RE: Crosby's Convenient Store
Route 242 & US Route 219
Ellicottville, NY 14731

SUBJ: Engineering Review of Site Plan Application

This is a response to the November 22, 2023, Barton & Loguidice, D.P.C. (B&L) Review letter.

ORIGINATED: 7-18-2023
 DRAWN: VE
 CHECK: JPG
 JOB: D2300115
 SHEET: C-4.0
 SITE GRADING PLAN

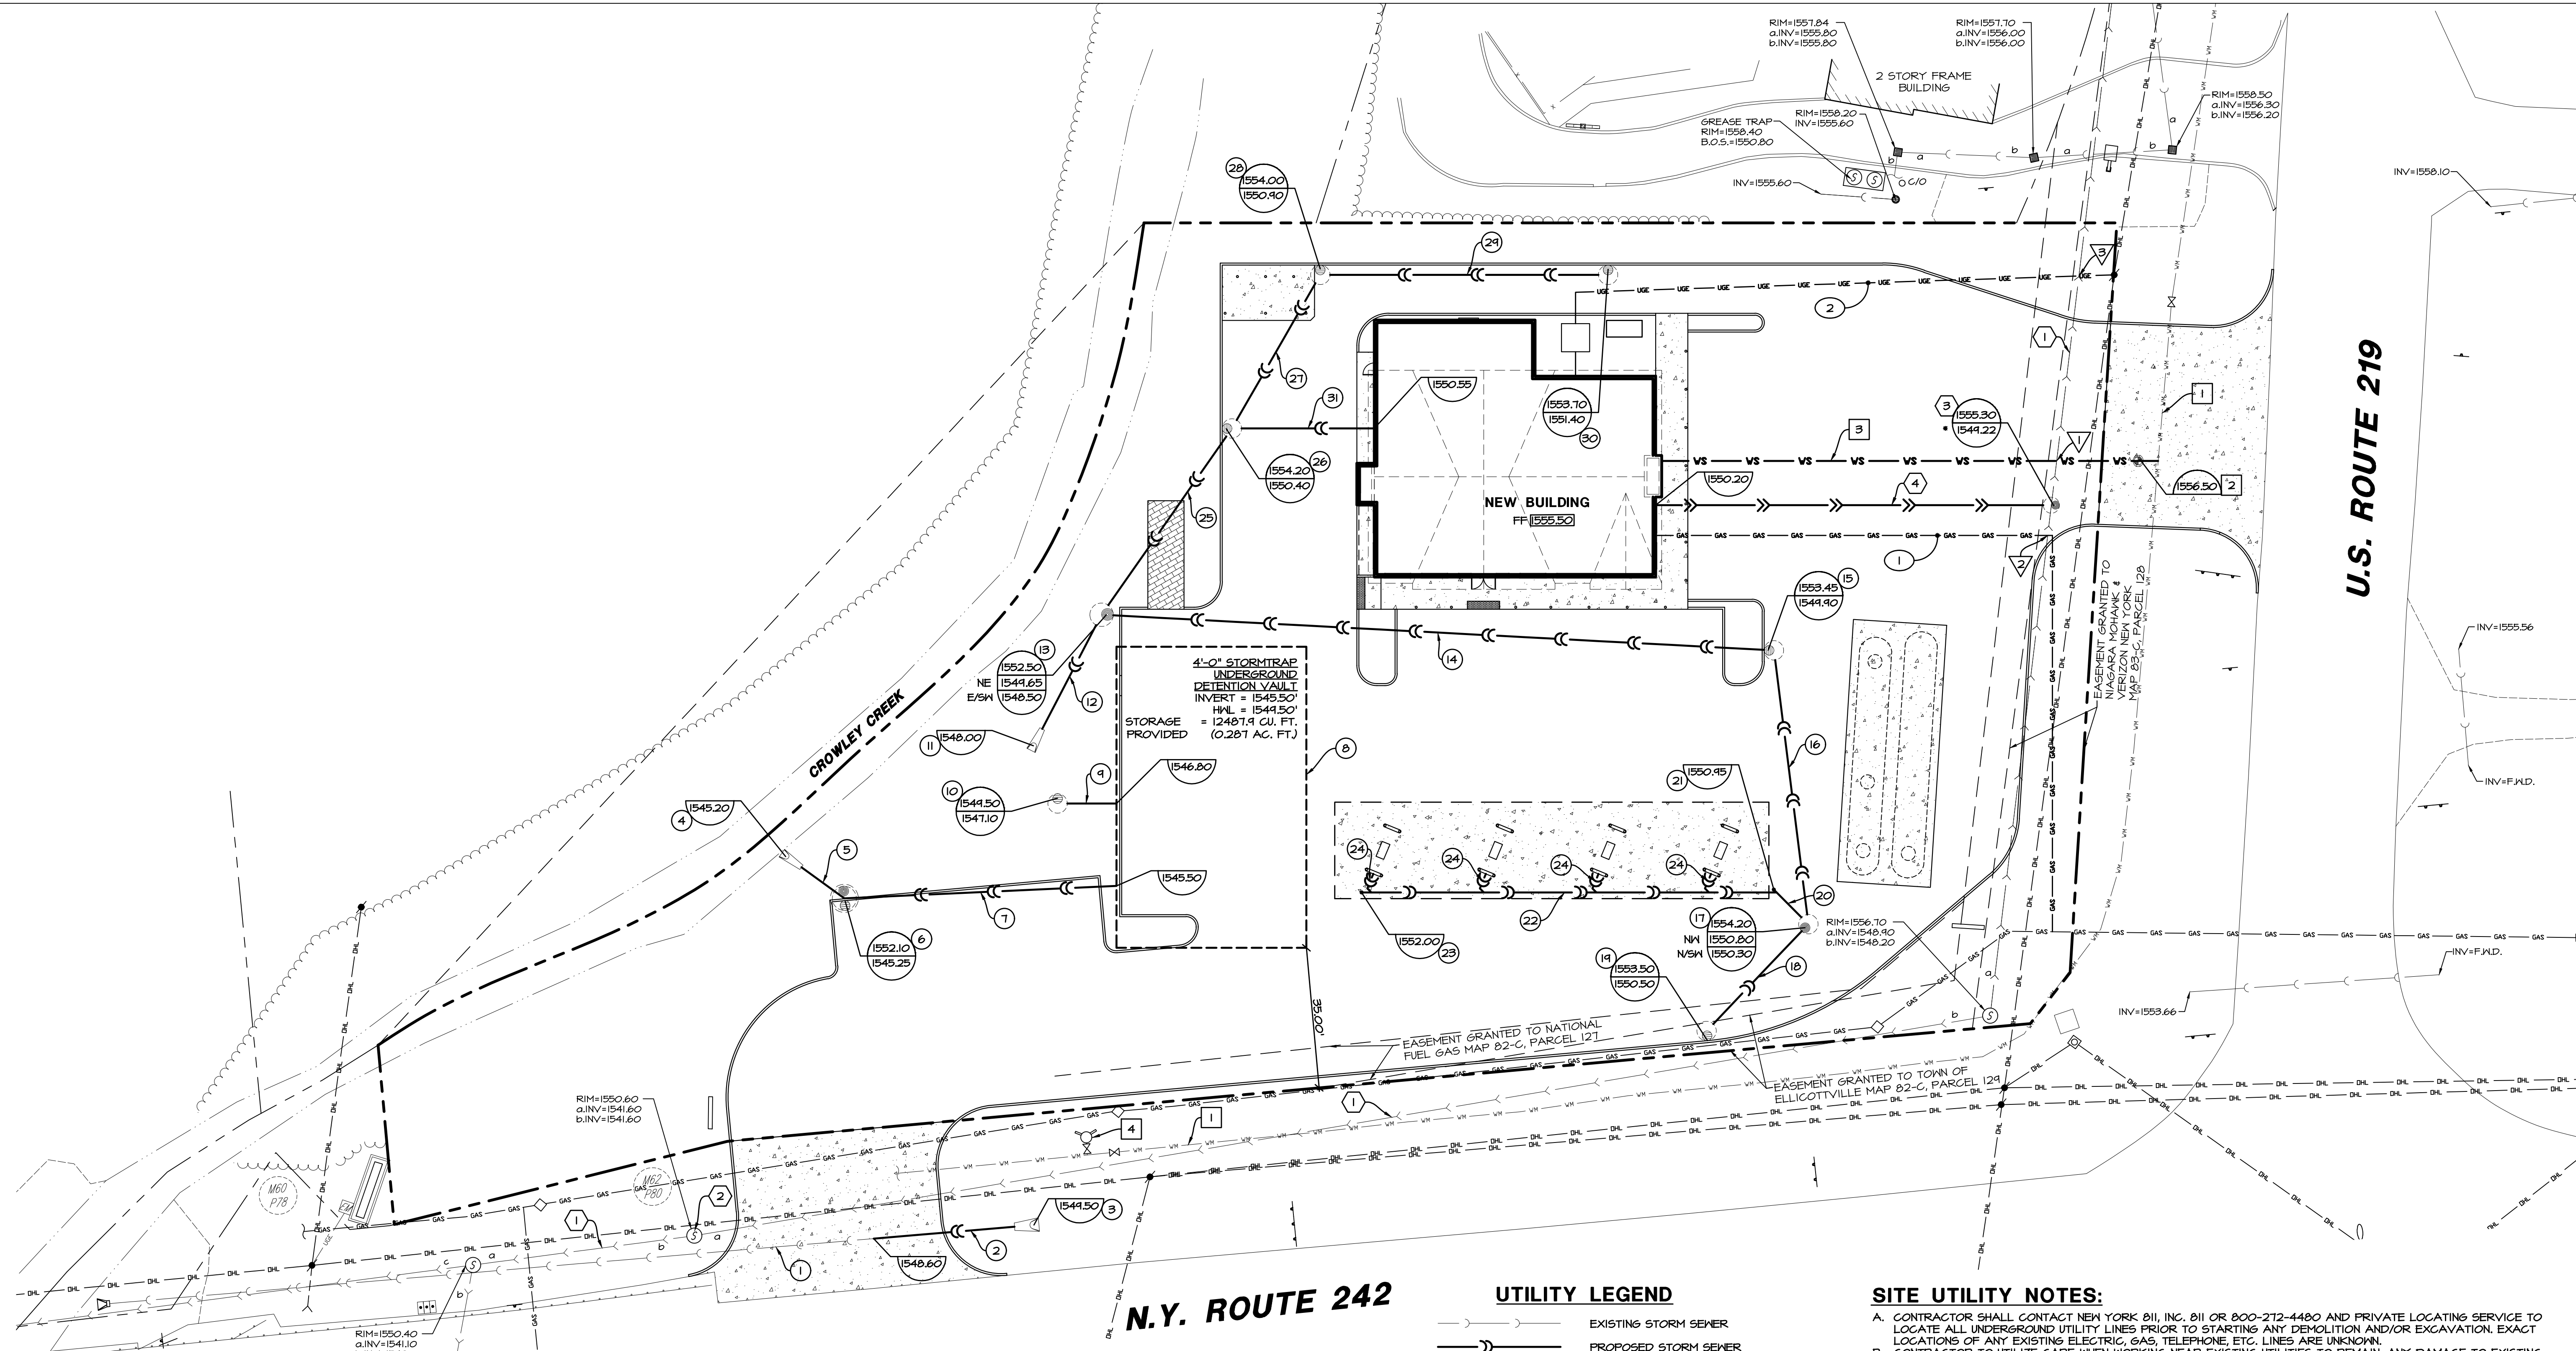
5. The plans label the proposed storm water pond area to be utilized for snow storage. It is recommended that snow storage areas be labeled up gradient of storm water management practices so that snow melt runoff can be captured and treated.

Response: Additional snow storage areas have been labeled throughout the site as shown.

ORIGINATED: 7-18-2023
 DRAWN: VE
 CHECK: JFG
 JOB: D2300115
 SHEET: C-5.0
 SITE UTILITY PLAN

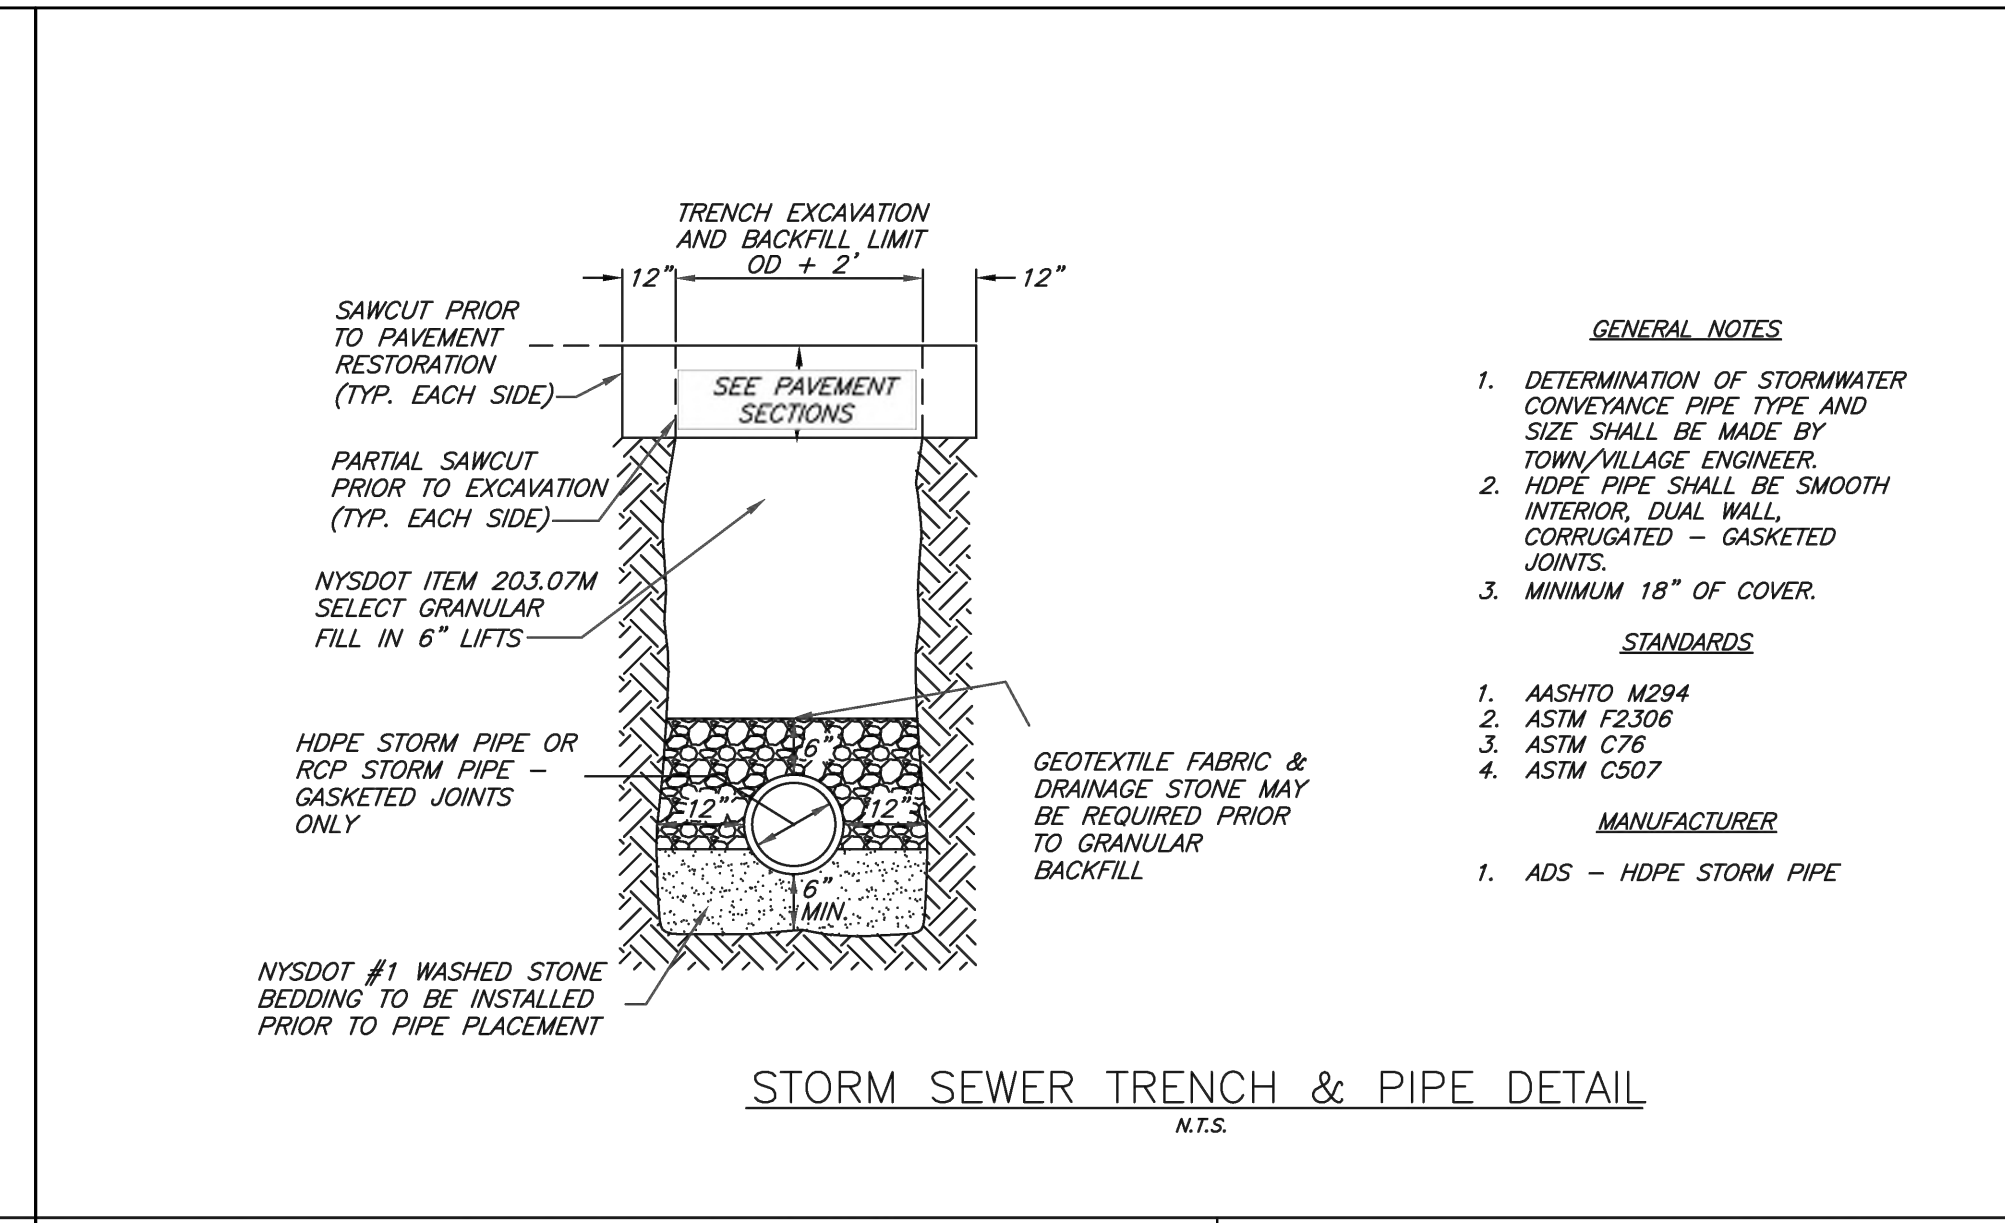
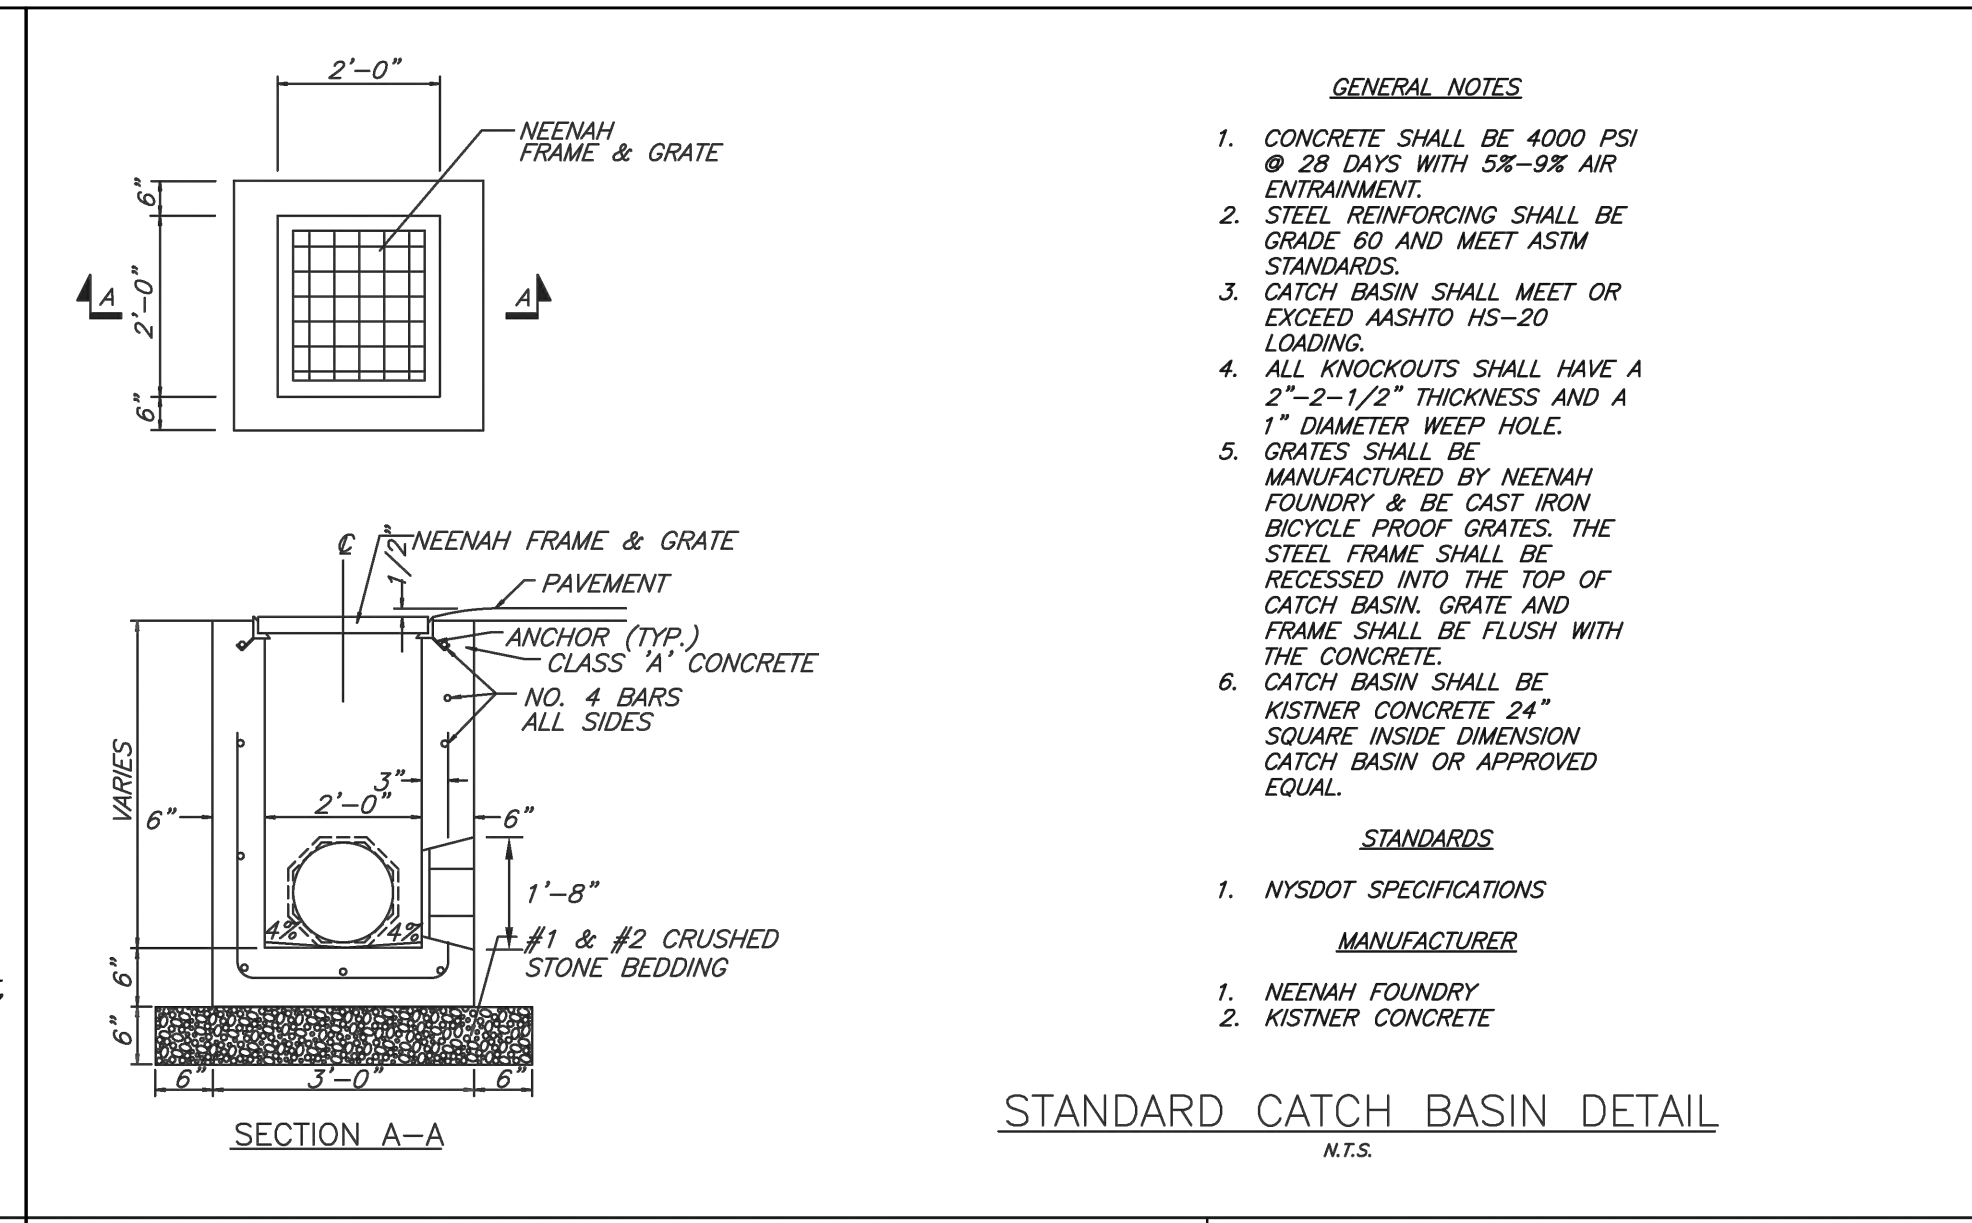
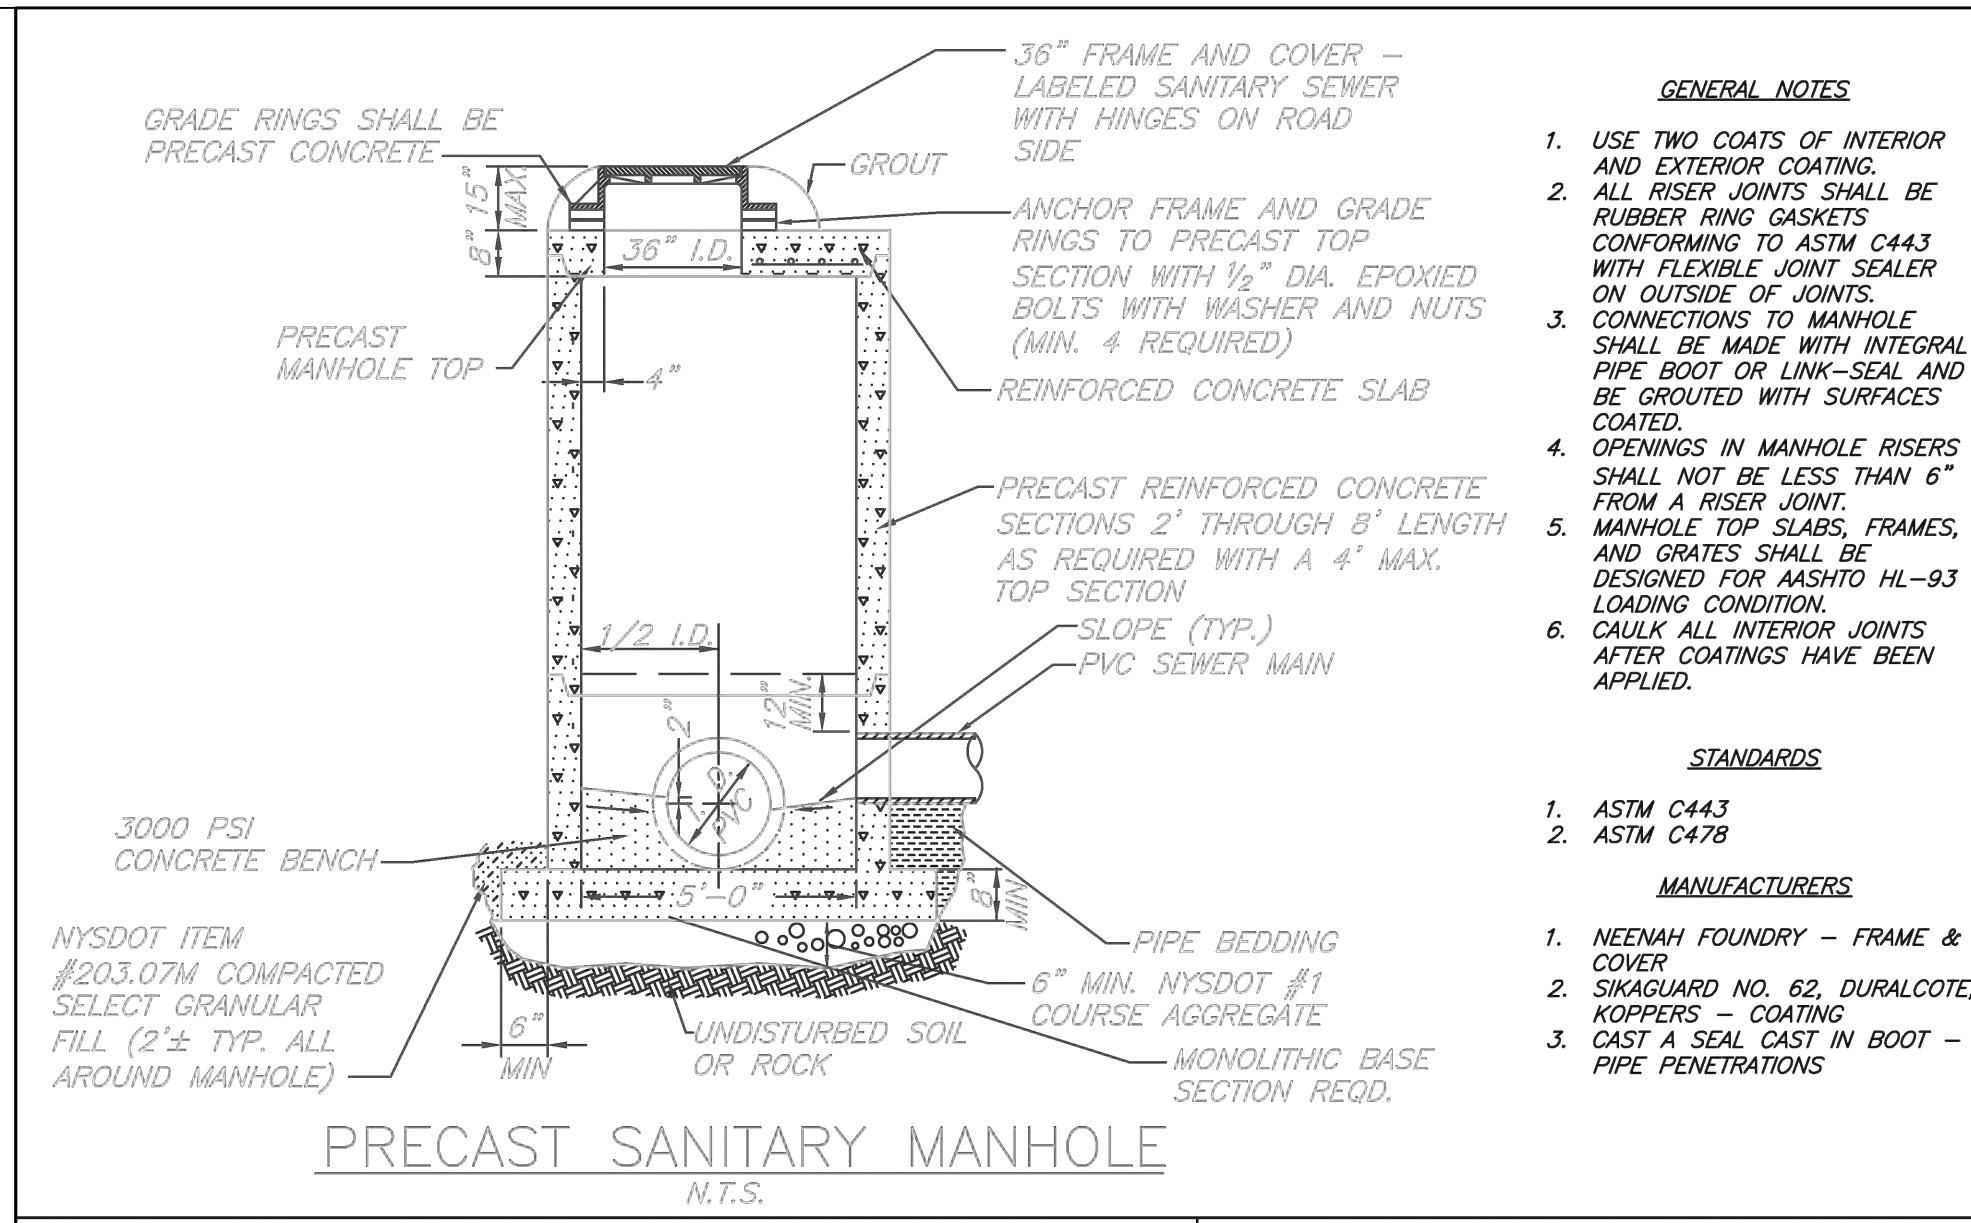
6. The utility plan should include proposed electrical and gas utility connections.

7. Please include all proposed water and sanitary sewer rim elevations and invert elevations on the utility plan.

Response: The proposed electric and gas service routings have been added to the Site Utility Plan, sheet C-5.0, as shown.

Response: All proposed rim and invert elevations have been added to the Site Utility Plan, sheet C-5.0 as shown.

Response: A Hydro International First Defense unit has been provided upstream of the proposed stormwater management facilities to capture any potential hydrocarbons in the site runoff prior to draining through the proposed infiltration and detention system as shown on the revised Site Utility Plan, sheet C-5.0.
